ADDENDUM No. 2

RFP No. 24-19

Miller Avenue Rehabilitation

I. CORRECTIONS/ADDITIONS/DELETIONS

CITY OF ANN ARBOR - PUBLIC SERVICES - ENGINEERING
MILLER AVENUE REHABILITATION
MILLER SECTIONS 4

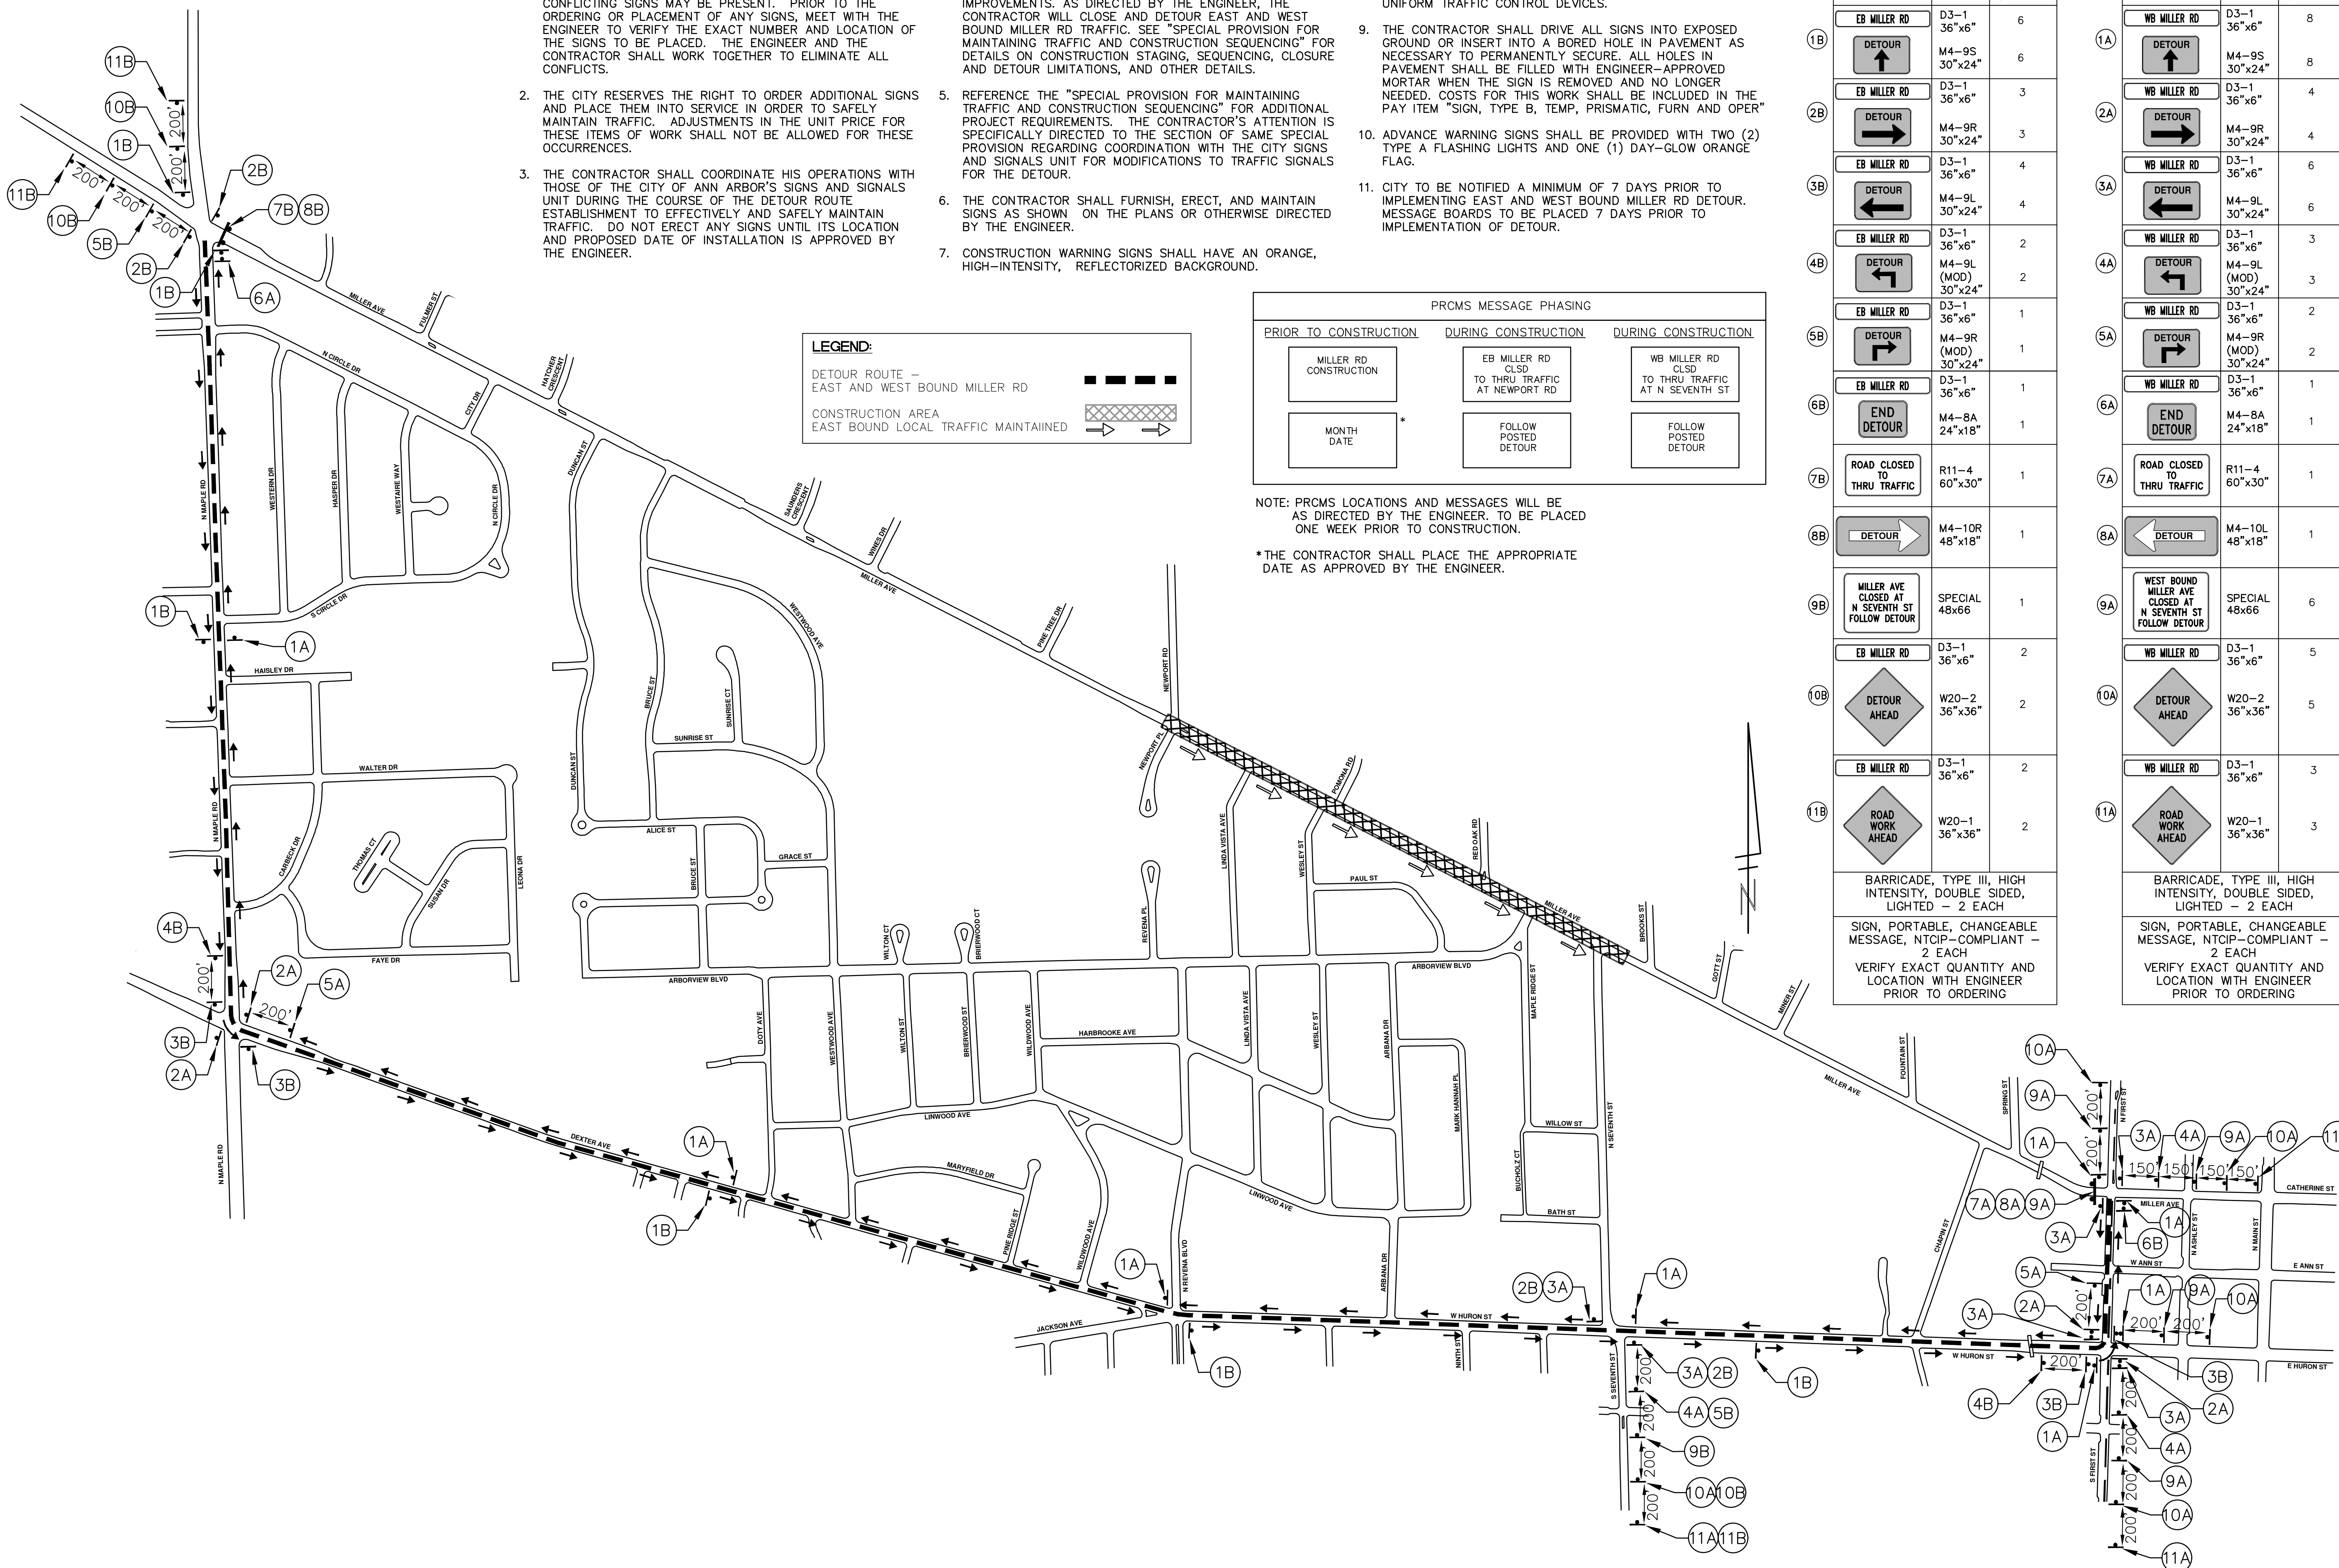
Question 17: On sheet 20, the cross section between STA 72+85 and POE conflict with the cross sections shown on sheet 21 (STA 79+00 to POE). Which is correct?

Question 18: Cross sections shown on sheet 21 do not match the removal sheets 44-45. Which is correct?

Answer 17: The POE on the top Typical Section on Sheet 20 in the should be 79+00, whereas the two Typical Sections on Sheet 21 are 79+00 to 82+50 and 82+50 to POE

Answer 18: The Typical Sections on Sheet 21 are representative of Removal Sheets 44 & 45. The Watermain trench is along the South side of Miller Ave and the entire width is getting 4.5" HMA, see Sheet 17 for HMA Application Table, after 4 HMA Cold-Milling. Hatching on the Typical Sections have been revised for clarification.
